STAFF REPORT

To: Lemoore City Council & Planning Commission
From: Holly Smyth, Planning Director
Date: December 29, 2010
Subject: Examples of Site Plan Review since the 2030 General Plan Adoption

SITE PLAN REVIEW & PARCEL MAP APPLICATION FOR DAVITA DIALYSIS CENTER – APPROVED BY PLANNING COMMISSION

Redlined Site Plan approved by Planning Director

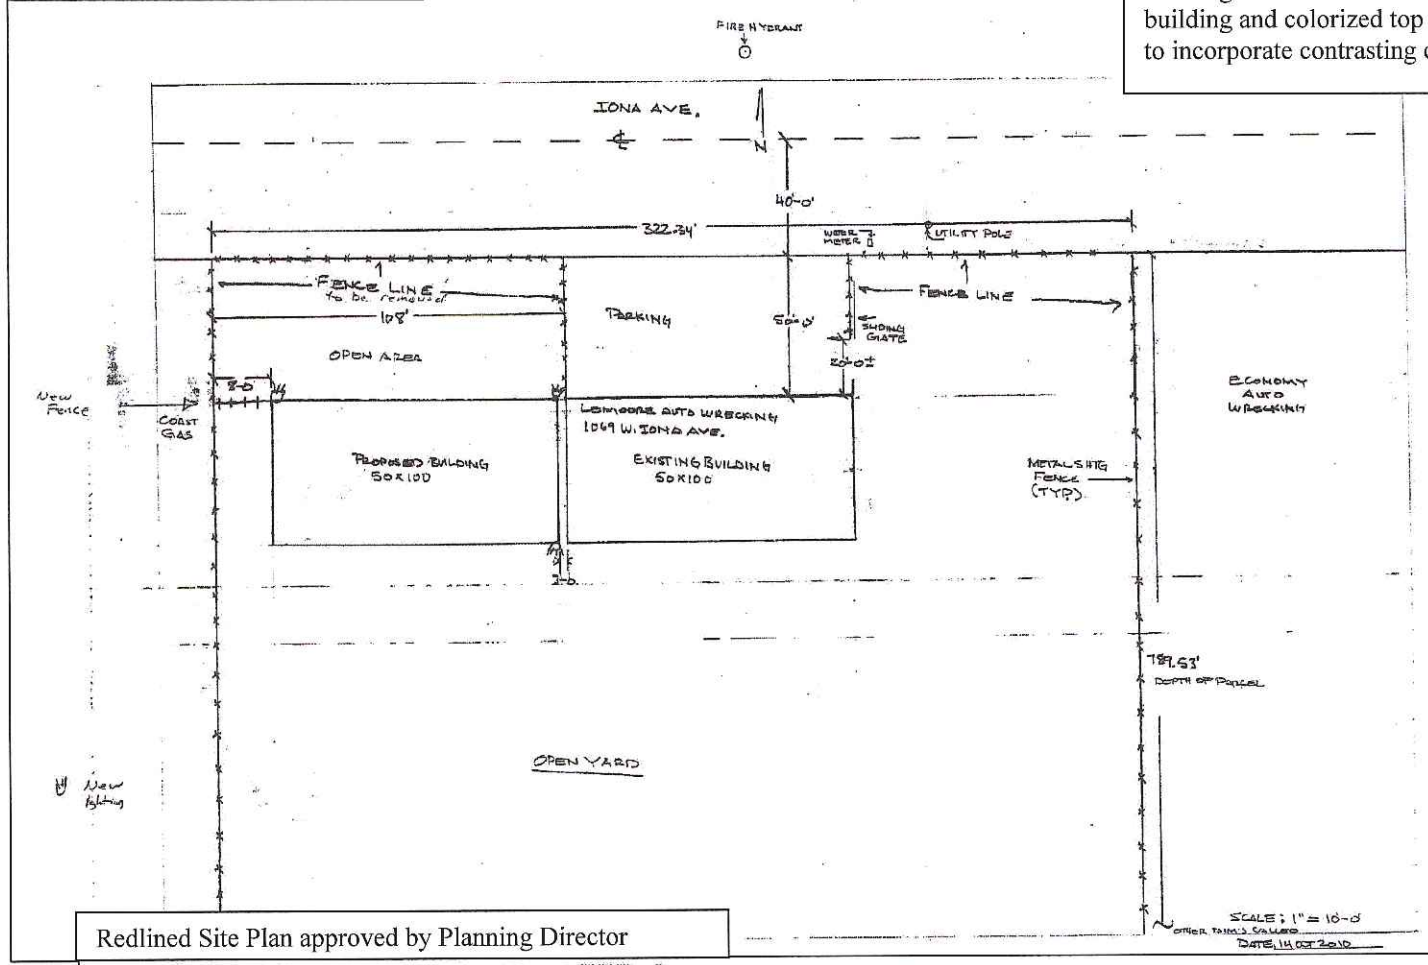
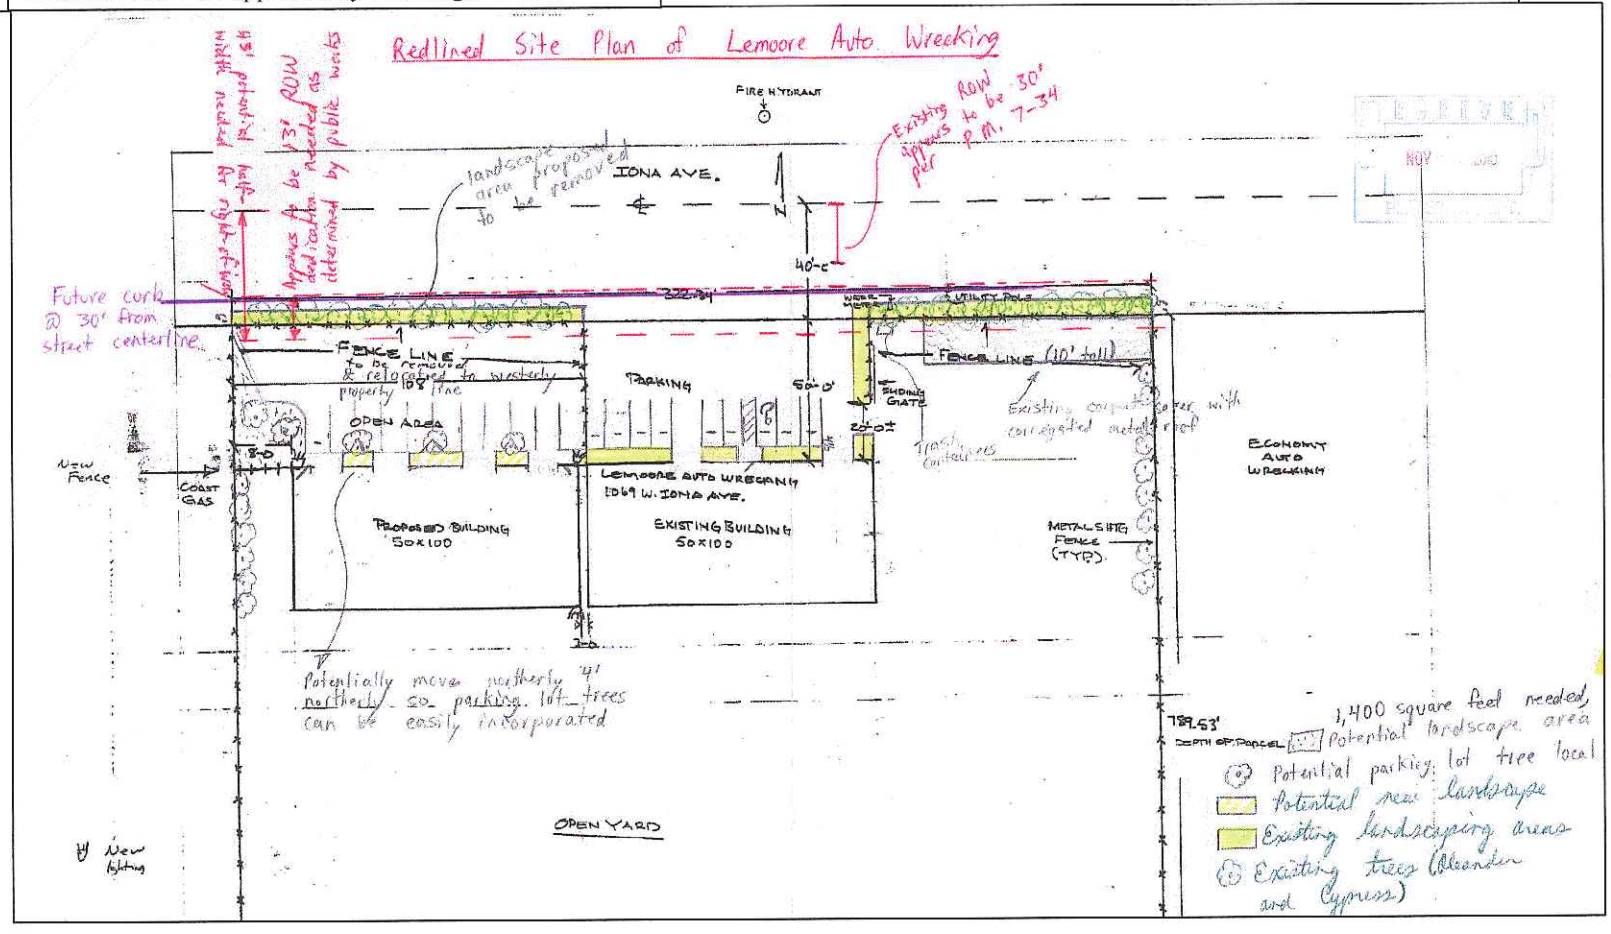
- Project involved the addition of a 5,000 sq ft storage building
- Original site plan didn't show all existing facilities, so staff went out to the site, took measurements and added information to base site plan to be complete versus giving back to applicant which would have significantly slowed down review (seams like the "smaller businesses" without draftsman struggle with development process more than others)

- In reviewing GP figures 4-1, 4-2, 4-3, 4-4, 4-5 and Table 4.3 regarding street improvements along with GP policies CD-I-7, CD-I-40, and CD-I-42 for landscaping, the requirements were very unclear, so one condition allowed for City Engineer to further determine right-of-way up to a 13' dedication if needed, another condition allowed more time to finalize the specific landscaping so staff could have a study session with Planning Commission, allowed for the deferral of several street related improvements.

Redlined Site Plan for rear addition approved by Planning Director

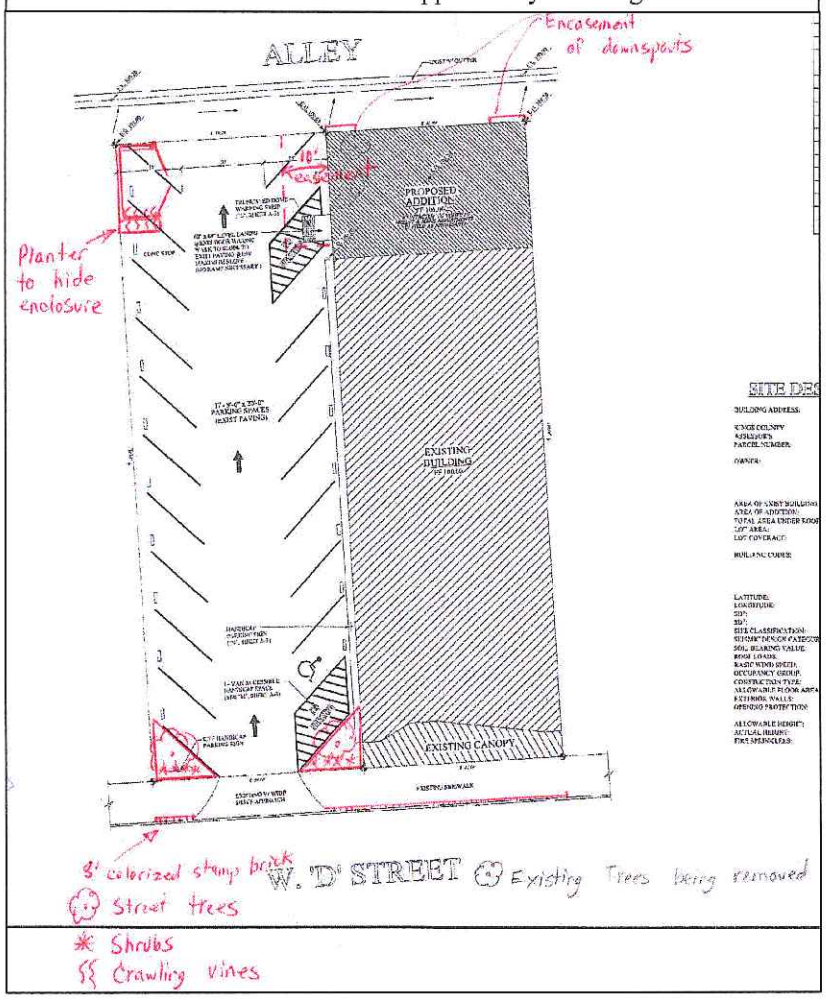
- Because of the long building length and closing off of the old alley exit on the north of the building, the new secondary entrance required 10' access easement be recorded on the parking lot. Due to inability of owners draftsman to draft appropriate legal description and recordation documents Planning Director drafted and City Engineer's office helped finalize for owners signatures and then took for recordation.

- Page 17 of the Lemoore Design Guidelines state that "Landscaping, garden walls, and fences should be used to screen undesirable areas such as trash bines, loading areas…" and therefore landscaping was incorporated in front of parking area and trash enclosure.

Original Elevations for rear addition with redlines incorporating Architectural Design Review Committee's modifications

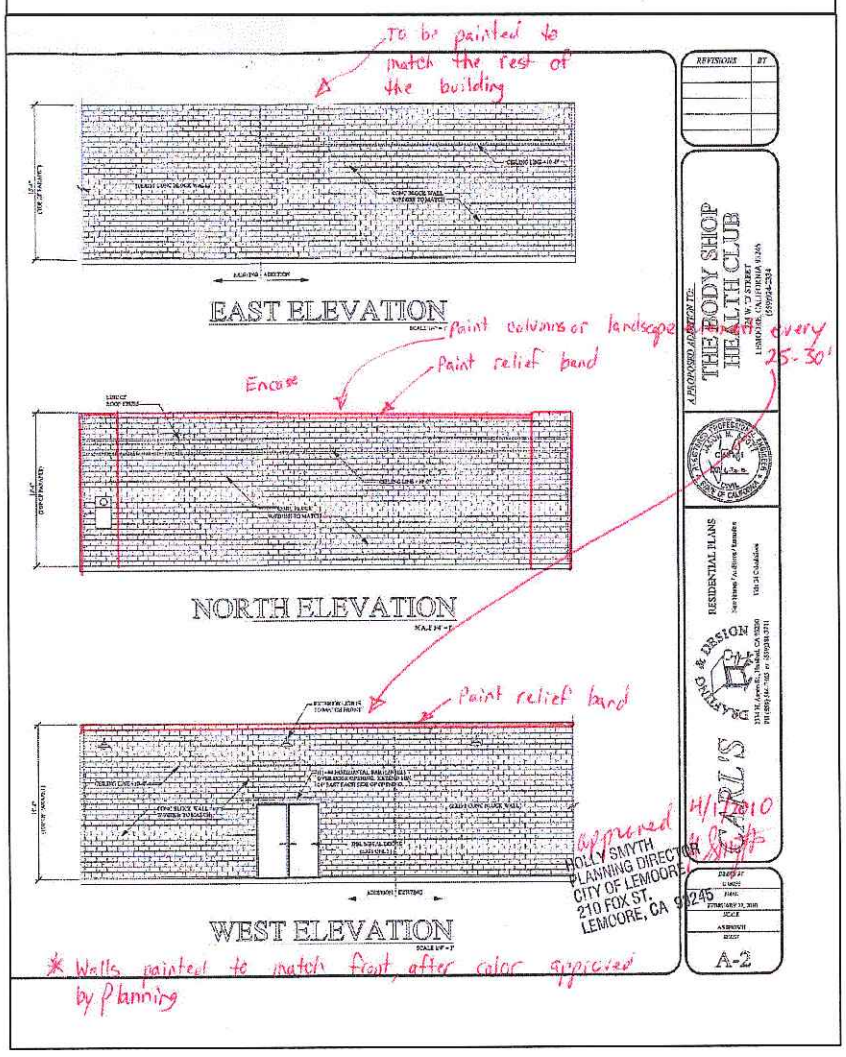
- Project involved the addition of a 5,000 sq ft storage building
- Applicant proposed painting of cement blocks around entire perimeter to cover old graffiti and help the new and old blend.

- Because new addition created a 150' long blank wall, either painted columns or landscape to be installed every 20-30' in line with General Plan policy CD-I-24 "….Massing…building must follow the rhythm of bays found in the district, each spaced approximately 20 to 30 feet apart". Relief band to be painted at top of building in lieu of cornice detail being added to meet relief banding policies on page 13 of the Downtown Design Guidelines. Neither of these paint details have been installed yet and are anticipated to be complete with the front façade project.

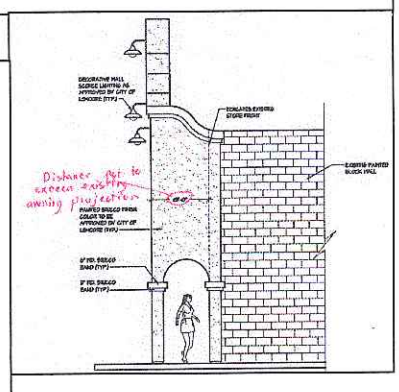
Approved side view of façade elevation with better tie-in back to the building which allows façade to permanently encroach into City right-of-way through the issuance of an encroachment permit. New Draft Downtown Form Based Code Ordinance better describes allowances for things to be in the right-of-way in the future.
